## RECALL ACTION

Reference number:	RA-18-2044	Issue Number: 1	Issued: 07 May, 2025
Subject:	Replace the Rear Fuse Box Closing Panel Screws		
Model(s):	Valkyrie, Valkyrie Spider		
VIN range:	Please refer to the separately published list of Vehicle Information Numbers (VINs)		
Applicable to:	All US Dealers		
Distribute to:	Head of Business After Sales Manager Service Manager Sales Manager	Warranty Staff Technician(s) Parts Staff

Figure 7

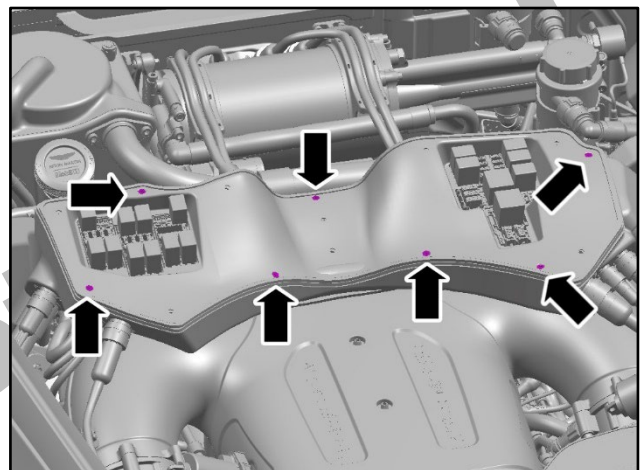
Incorrect length screws were used to attach the rear fuse box closing panel in some vehicles. The incorrect screws may be able to clash with the wiring harness.

7. Remove and discard the seven screws (refer to Figure 7).

On the affected vehicles it is necessary to replace all the screws for the fuse box closing panel with 9.53 mm screws.

Figure 10

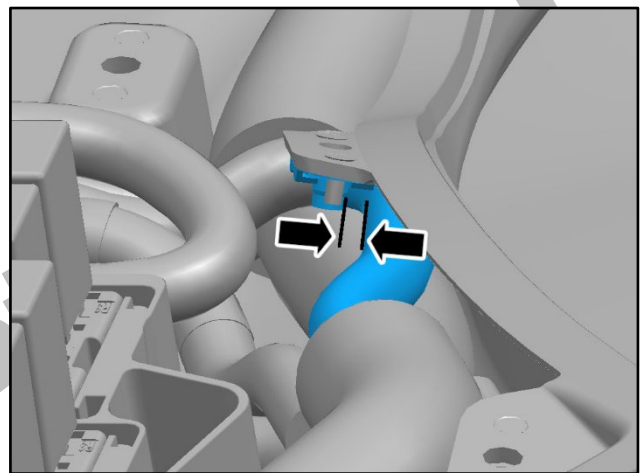
- 10. Confirm the clearance between the captive nut for the bolted joint and fuse box harness is at least 3.0 mm (refer to Figure 10).

If the clearance is less than 3.0 mm, submit a report to the Valkyrie Aftersales team. This report should contain the VIN, mileage, and images of the area of concern.

Figure 11

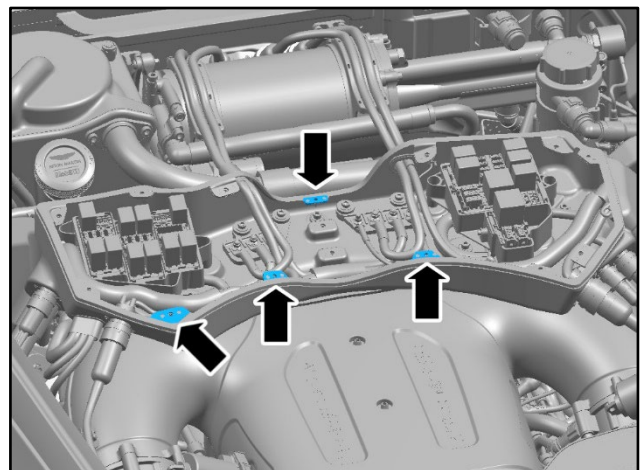
- 11. Examine the fuse box for any damage in the indicated areas below the bolted joints (refer to Figure 11).

If any damage is discovered, submit a report to the Valkyrie Aftersales team. This report should contain the VIN, mileage, and images of the damage.

Figure 13

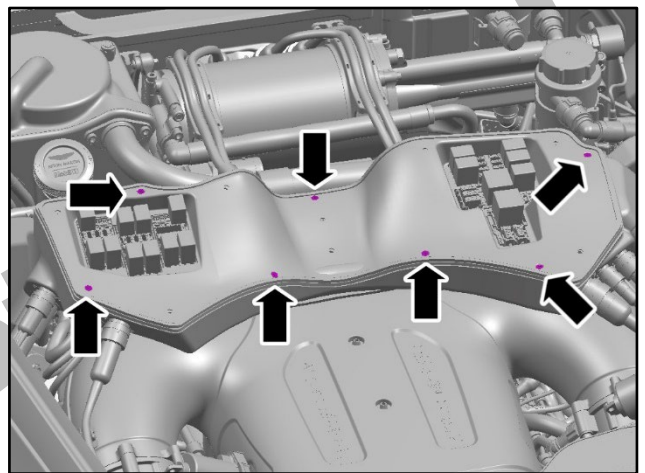
13. Install and torque the seven 9.53 mm screws to 5 Nm (refer to Figure 13).
